PENRITH CITY COUNCIL

MAJOR ASSESSMENT REPORT

Application number:	DA19/0314
Proposed development:	Demolition of Existing Structure and Construction of a Three (3) Storey Boarding House containing 12 Boarding Rooms with At Grade Car Parking
Property address:	77 Lethbridge Street, PENRITH NSW 2750
Property description:	Lot 15B DP 344265
Date received:	9 May 2019
Assessing officer	Paul Anzellotti
Zoning:	Zone R4 High Density Residential - LEP 2010
Class of building:	Class 3
Recommendations:	Refuse

ELEVATIONS 1330.DA05

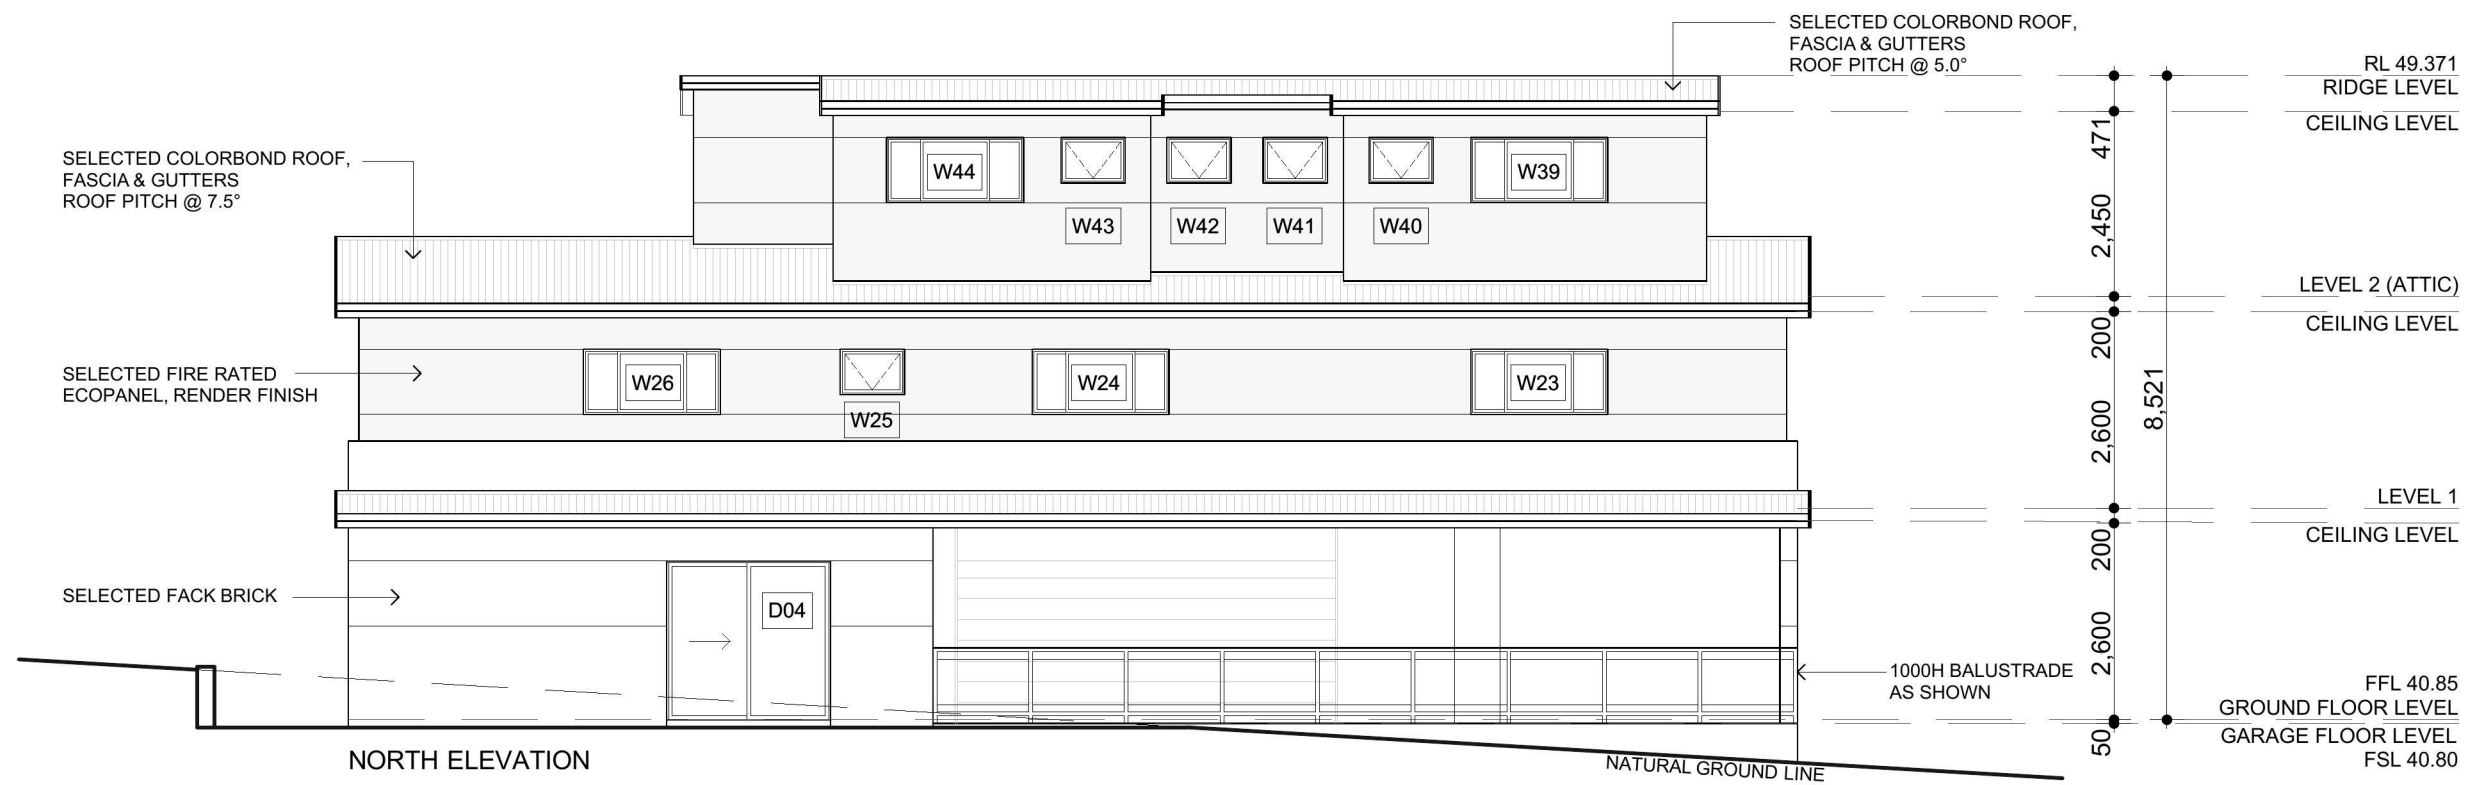
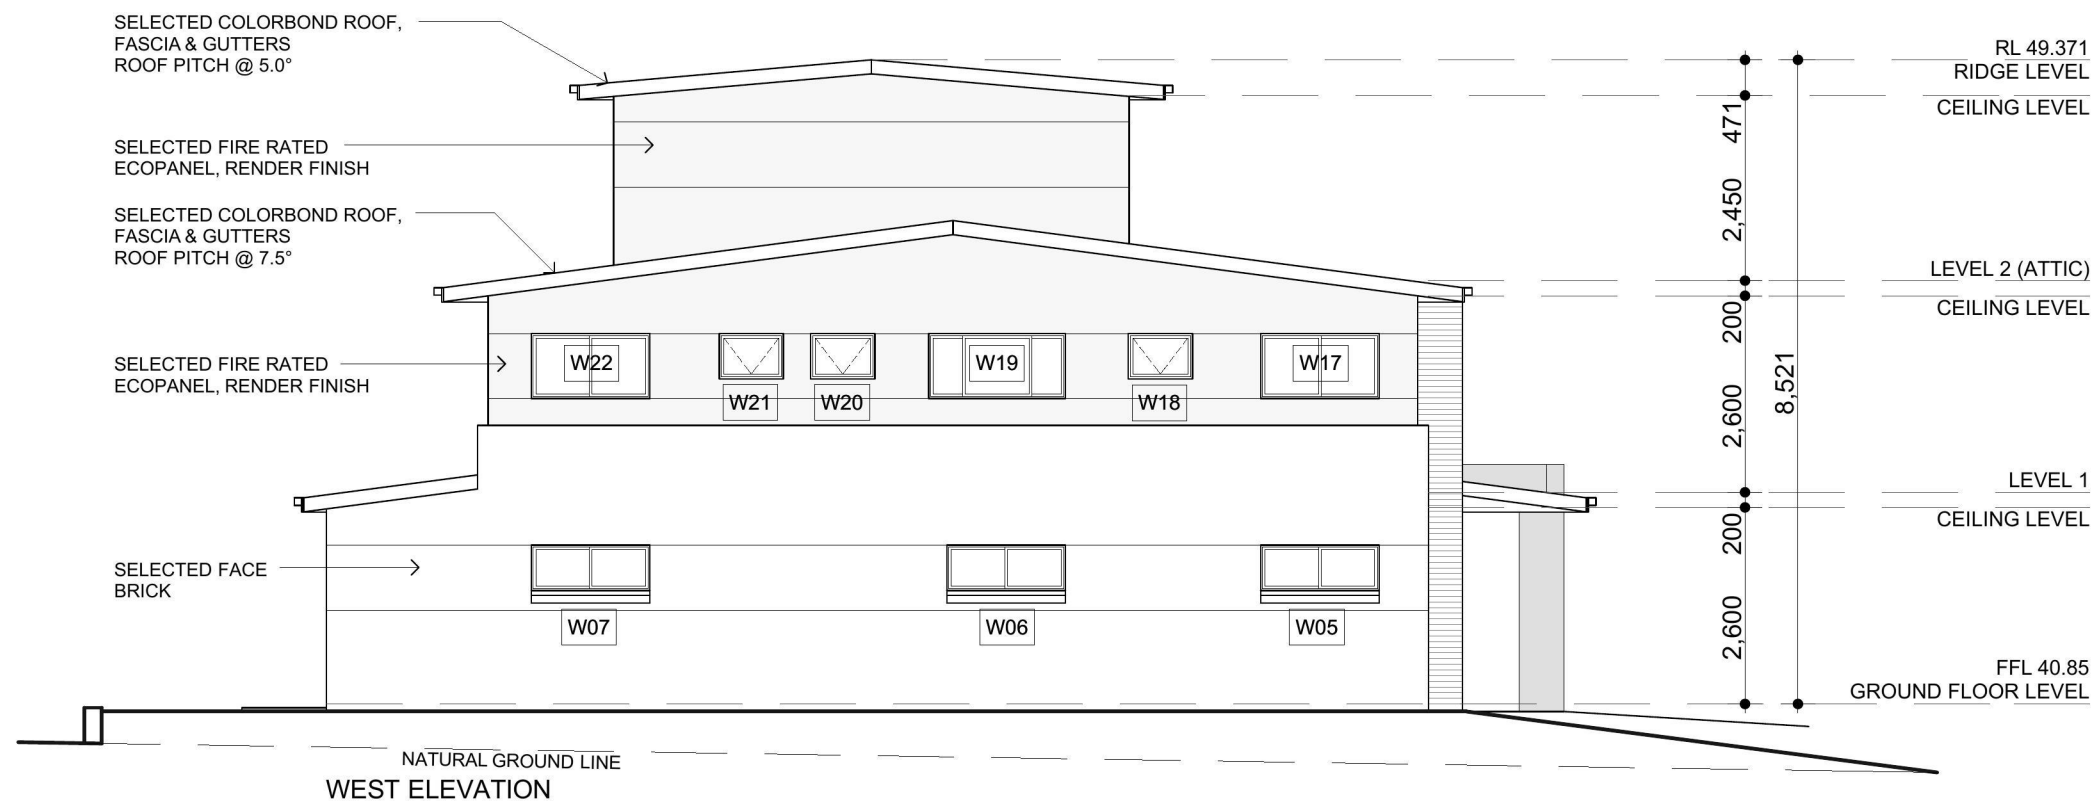
Noting the above, the first floor layout does not step in plan resulting in bulk and overbearing impacts, and architectural elements along the side elevations such as the double height walls do not ameliorate bulk and scale or provide relief from the overall height of the building. The built form is considered to provide for an irregular and disproportionate looking building which is not considered an appropriate inclusion to the streetscape.

The west facing elevation will be unshaded and no significant landscaping is provided to reduce the reliance on air conditioning. The location of proposed individual air conditioning units is not shown on plans and the related visual and acoustic impacts of these units cannot be ascertained with the current design.

It is also noted that finished floor levels are not nominated on architectural plans indicating further potential concerns with the design.
